Re: 339 West Gorham Street: Oliv Madison

Attached is a minor amendment packet for the Oliv Madison Project. These changes address some program elements (expanded amenity), design refinements, and adding solar to the project. The packet illustrates the changes between the Original SIP document and the proposed amendments. The site plan review/building permit set elevations are also included for reference to show what was approved with the building permit.

UDC MINOR REVISIONS

ōliv MADISON 339 W GORHAM STREET

BUILDING HEIGHT RELATIVE TO STATE CAPITOL
 HEIGHT = GRADE + BUILDING HEIGHT - CITY DATUM
 = 873.10 + 132.0 - 845.6
 HEIGHT = 159.5FT < 187.2 (STATE CAPITOL BLDG.)

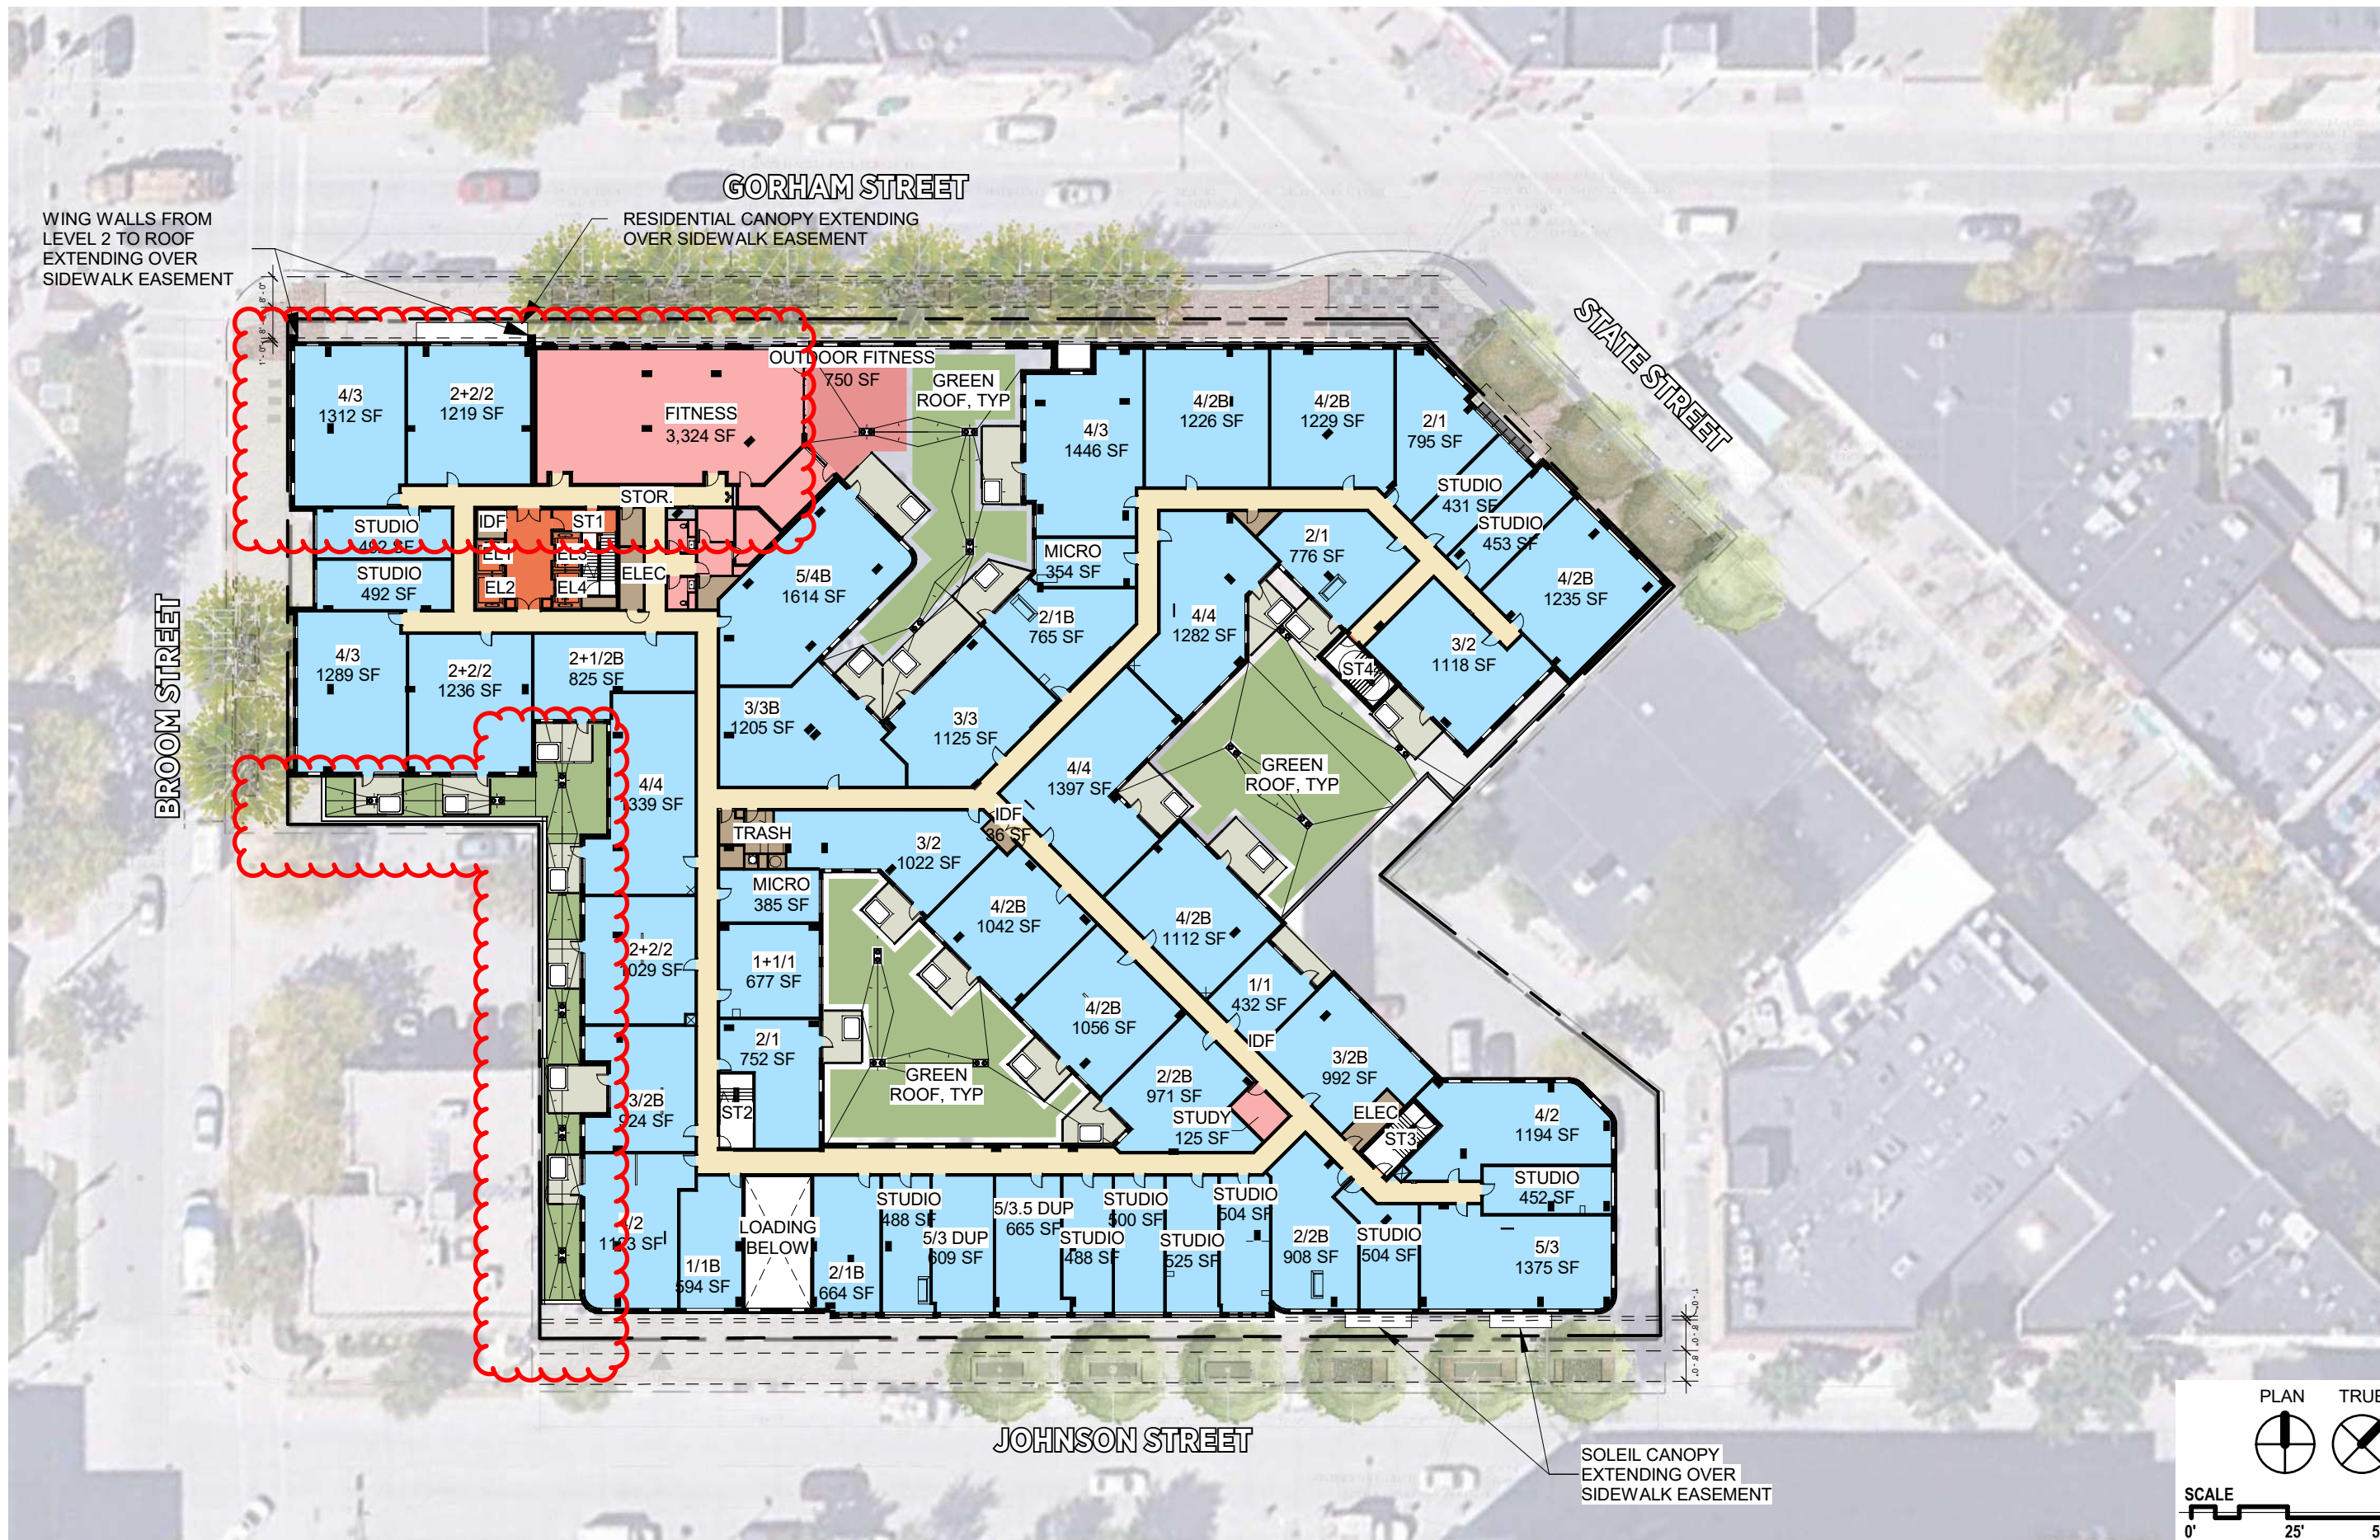
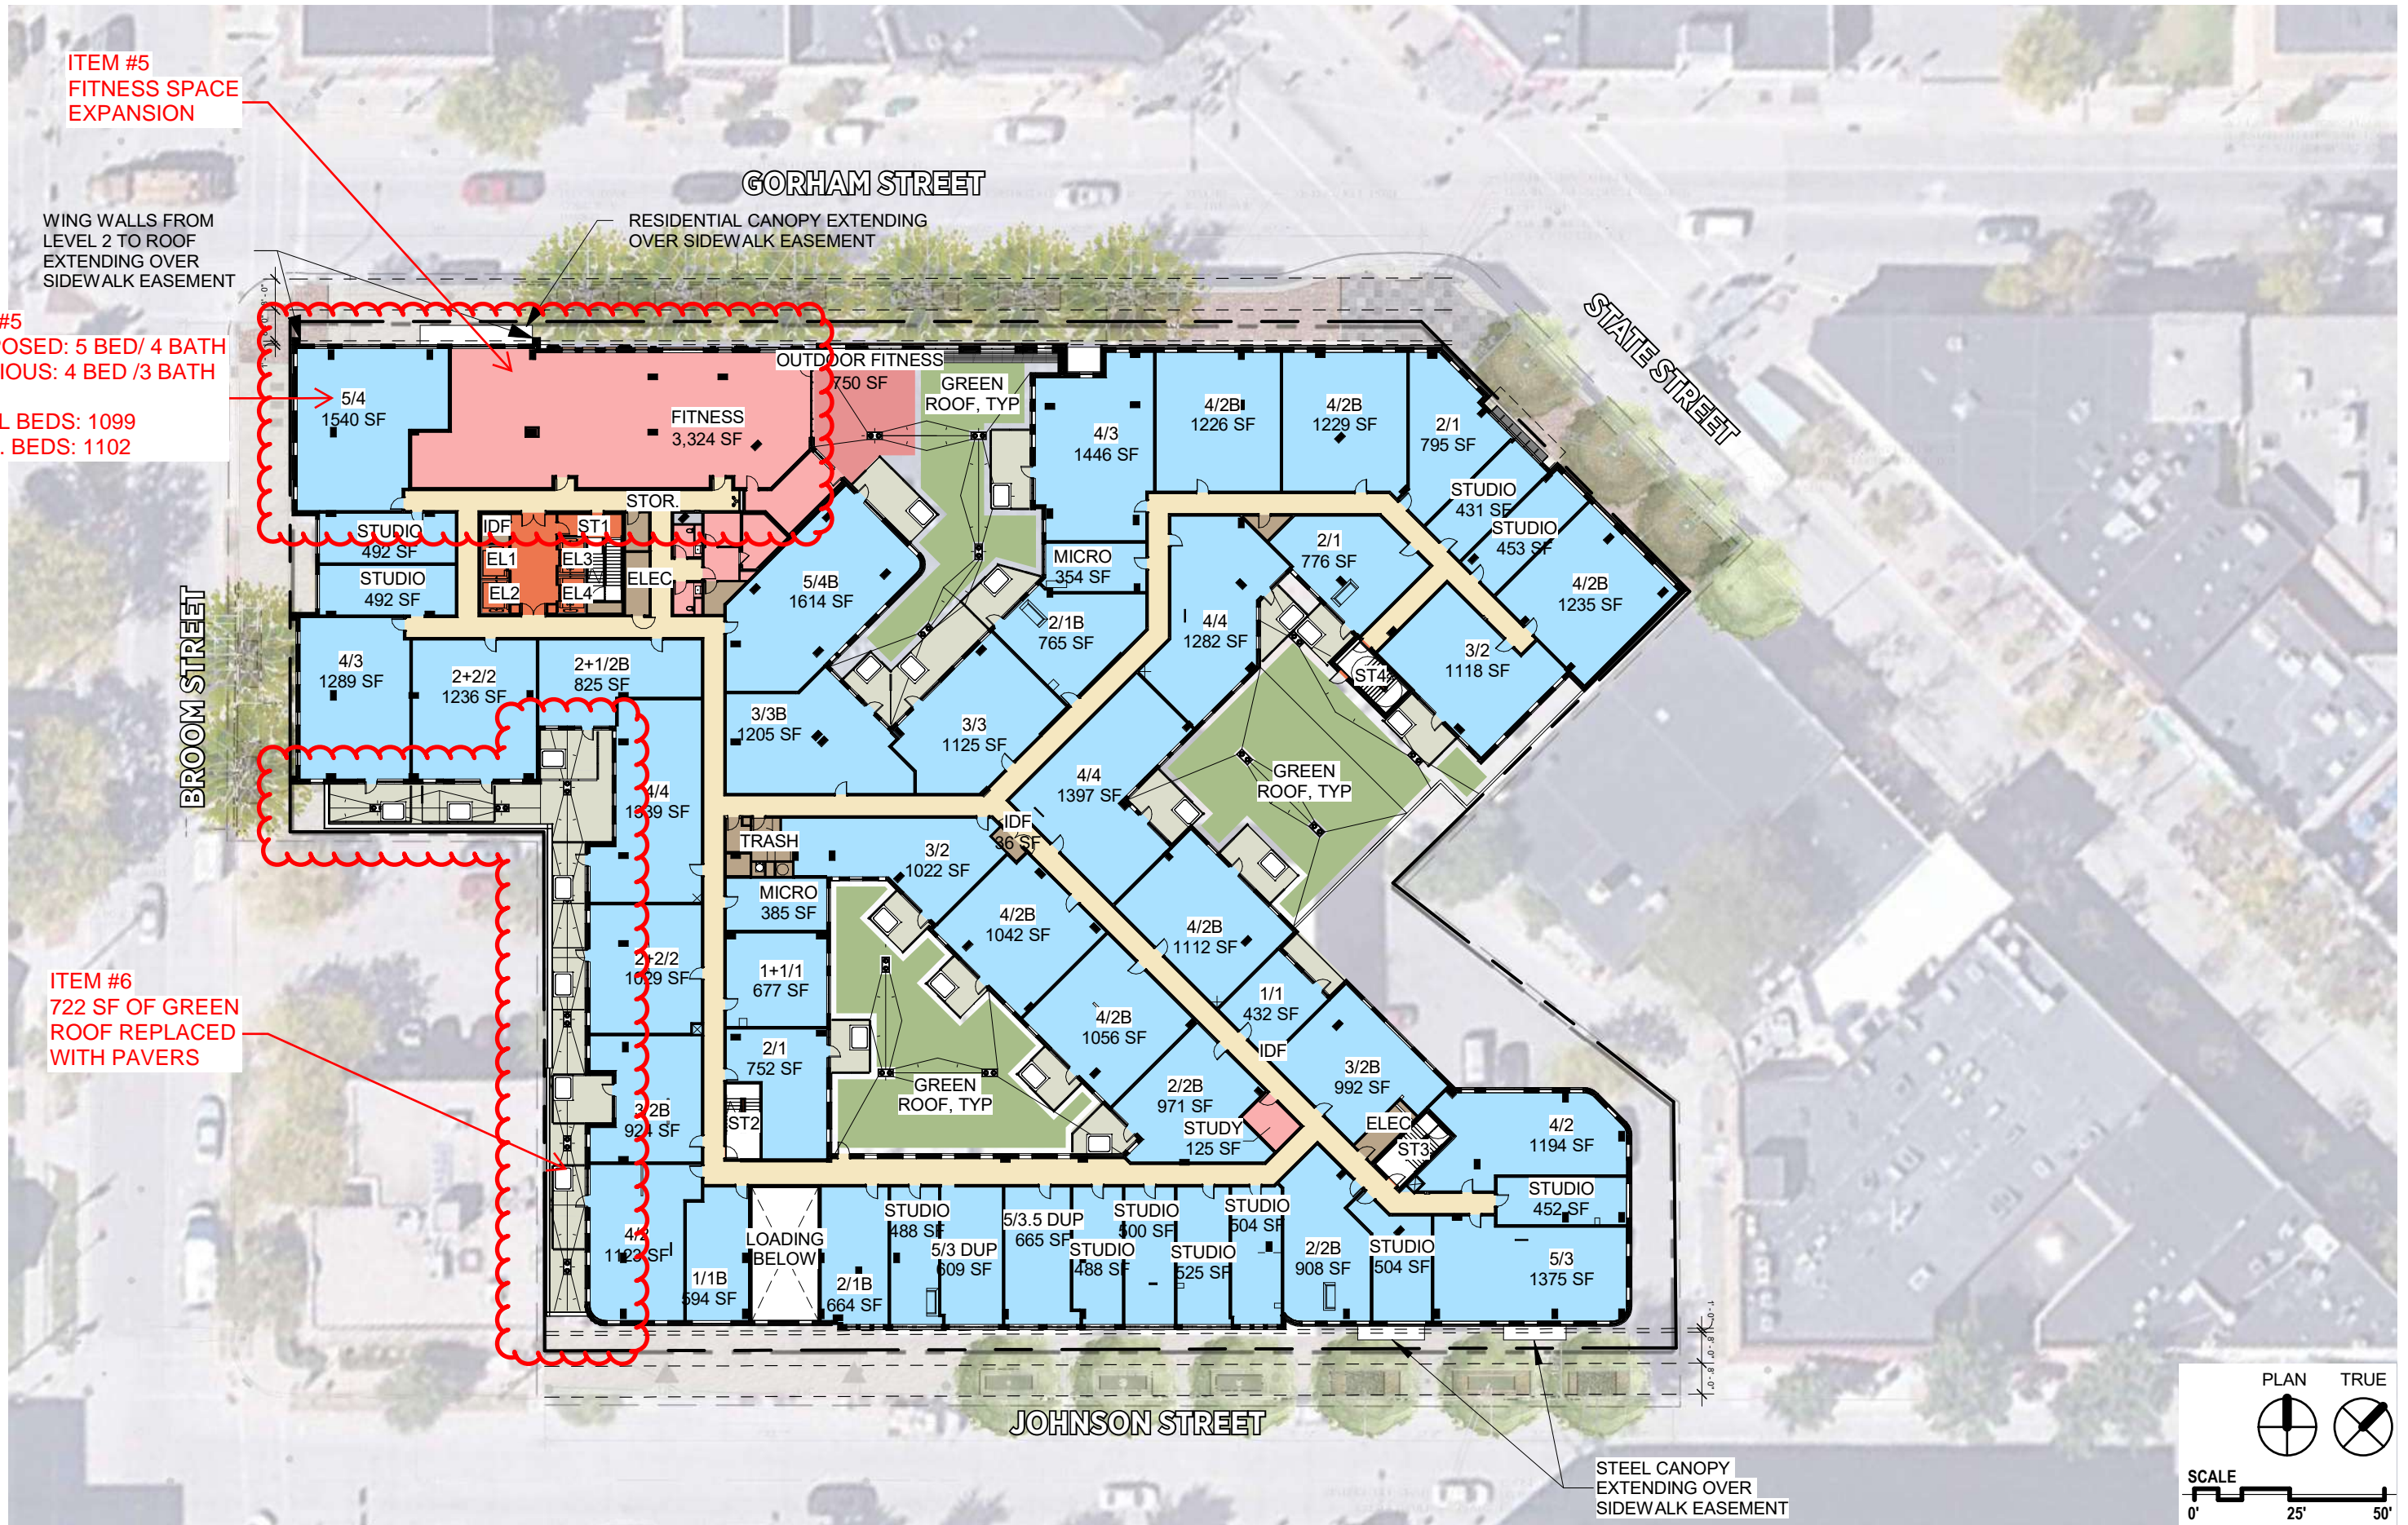
ITEM #28
WINDOW SPACING ADJUSTED TO ALIGN WITH UNIT LAYOUTS - TYPICAL ON ALL FACADES

ITEM #27
GLASS RAILING DEVELOPED FURTHER THROUGHOUT BUILDING - TYPICAL ON ALL FACADES

ITEM #15
SELECT TENANT BALCONY RAILINGS CHANGED FROM GLASS TO PICKET FOR DESIGN PURPOSES

ITEM #29
JOHNSON STREET ALLEY SETBACK

ITEM #13
PARAPETS INCREASED IN HEIGHT TO ACCOMMODATE REQUIRED ROOF ASSEMBLY

ITEM #16
JOHNSON FACADE CORNER WINDOW

ITEM #23
LOUVER REQUIRED PER MECHANICAL DRAWINGS.

ITEM #4
RESIDENTIAL GARAGE DOOR HEIGHT REDUCED - BRICK DETAILING ADDED. GARAGE DOOR LITES REVISED PER DOOR MANUFACTURER STANDARDS

ITEM #18
EGRESS DOOR

ITEM #25
CURVED GLASS REPLACED WITH CURVED METAL PANEL TO CONCEAL COLUMN.

ITEM #3
PROPOSING ALUMINUM LOUVERED CANOPIES AT RETAIL STOREFRONTS.

ITEM #24
HISTORIC FACADE UPDATED PER DESIGN DEVELOPMENT AND LASER SCAN
